SITE:
Peartree Hill Solar Farm

Peartree Hill Hydraulic Modelling Report (20-206-60-050-01)

Consultation Record

Meeting Title	Hydraulic Modelling Discussion
----------------------	--------------------------------

Figure 1: Locations on the River Hull which intersect the red line boundary for the site where breaches are not proposed.

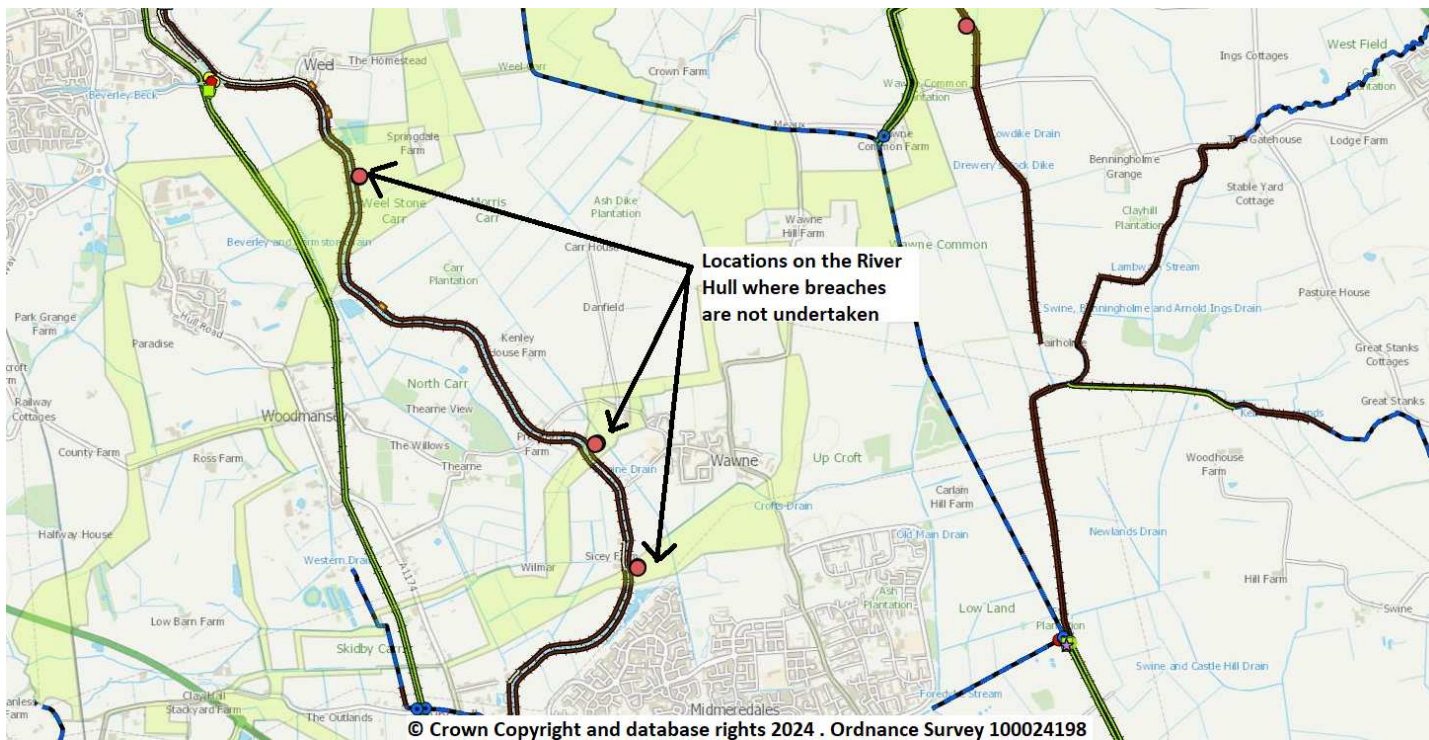
What was the rationale for not undertaking a breach at east 506700 north 438725, east 508280 north 436920, and east 508565 north 436090 on the left and right bank of the River Hull (figure 1 below)? Is this because these are relatively low risk areas for cable routing?
